# United States Patent and Trademark Office

APPLICATION NO.	FILING DATE	FIRST NAMED INVENTOR	ATTORNEY DOCKET NO.	CONFIRMATION NO.
10/814,597	04/01/2004	Jean-Pierre Rene Leon	403005/WEINSTEIN	5887 .
23548 75	90 01/21/2005		EXAMINE	ER
LEYDIG VOIT & MAYER, LTD 700 THIRTEENTH ST. NW			SHARP, JEFFREY ANDREW	EY ANDREW
SUITE 300			ART UNIT	PAPER NUMBER
WASHINGTO			3677	
	•		DATE MAILED: 01/21/2004

#### **DETAILED ACTION**

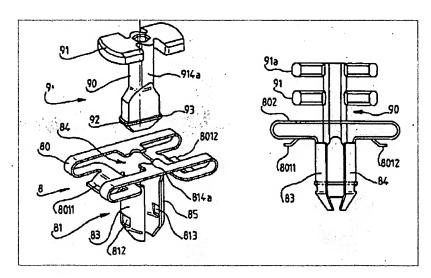
Leon et al. teach a female piece having a clasp, hollow elastically deflectable head, hollow foot portion having two tabs, and a male piece having a head (having a second head element (91), shaft, and cam portion. In general, Leon et al. teach substantially all of the claimed limitations, except for a **notch on the head** of the male piece that receives a **component** projecting from the head of the female piece -- said component comprising a resilient and axially-deflectable **finger** at its free end.

Higdon et al. teach a device for use in joining at least two panels together (Col 1 lines 7-9), comprising an anti-rotation apparatus. The anti-rotation apparatus has both locked and unlocked positions; both positions being facilitated by resilient, axially deflectable tab-like components (70) that extend from a female piece (30), and which have bent-like finger portions at their free ends. The fingers (70) are deflectable in an axial direction with respect to the shaft (54,60) axis of the male piece (50), and engage a **notch** (68) in the head (52) of the male piece (50), so as to prevent accidental rotation of the male piece (50) within the female piece (30). Accidental rotation of the male piece (50) is undesirable (as stated by Applicant in vibration environments), because it threatens the accidental. The male piece (50) is provided with a larger head portion (56) to prevent further insertion into the female piece (30). In order to achieve an unlocked position (i.e., position which allows rotation of the male piece (50) within the female piece (50)), the fingers (70) are axially deflected in between the two head portions (52, 56) and out of the notch (68) of the head (52). This is facilitated by ramp segments (66) which are not critical, but make the transition between *locked* and *unlocked* positions smoother. Note that Higdon et al. specifically disclose that clearance flats are necessary for the first head

At the time of invention, it would have been obvious to one of ordinary skill in the art, to modify the fastening device taught by Leon et al., to comprise the anti-rotation device (i.e., 'resilient finger components' on a female piece, and a 'notch' on one of a plurality of head elements on a male piece), as suggested by Higdon et al. and substantially discussed above, so as to prevent accidental rotation of the male piece within the female piece when the male piece is in a fully inserted position. Accidental rotation would undesirably cause loosening or separation of the panels.
